No: SB062 Rev: 0 Date: March 12, 2013

Over-Stressed Torque Restraint
On 350-EXI-600 Top Drive

Tesco Corporation 5616 – 80th Avenue SE Calgary, Alberta, Canada T2C 4N5 Tel: 1-877-TESCO-77 (North America) Tel: 1 (713) 359-7195 (AMSS 24-hour support)

Figure 1: Upper clevis weld of EXI torque bushing front plate sheared off from top drive

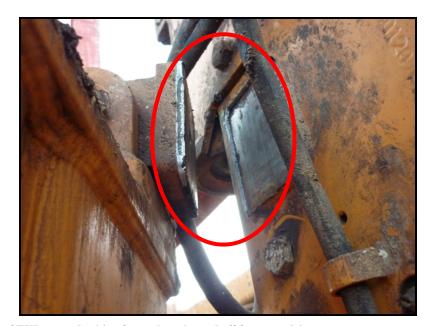
Issue 2: An investigation has also found that a lack of fusion between the weld material and the clevises was a significant contributing factor in this failure. TESCO identified a single vendor that had provided faulty torque bushing products since 2010. As a field retrofit procedure, TESCO is recommending to grind out the existing welds and replace them with a revised weld. A revised drawing of the front plate (810331 Rev4) has been issued to assist in the rework of all existing units.

Notwithstanding the fact that this incident did not result in significant damage, if a similar failure were to occur while rotating, severe damage (up to and including injury or death) could result from the top drive rotating unrestrained in the mast. TESCO advises that the top drive should not be used to provide rotation (drilling, torqueing of connections, etc.) until such time as a repair is undertaken.

Figure 2: EXI torque bushing front plate

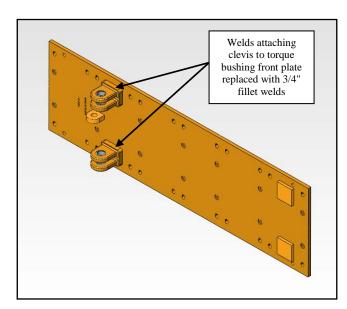
- The welds attaching the clevises to the torque bushing front plate (TESCO part number 810331, Figure 2) are to be fully ground out and replaced with 3/4" fillet welds under an approved weld procedure for A514 grade material (Quenched and Tempered 100 ksi yield plate) as specified in drawing 810331 Rev4.
- 2. Ensure that the rework is performed by a qualified welder using an approved weld procedure specification suitable for A514.
- New cylinders (TESCO part number 0926) are to be installed with cylinder stop tubes (TESCO part number 5012642) to prevent the cylinders from locking when fully extended.

**Note:** This will limit the extend feature to 57" instead of 60".
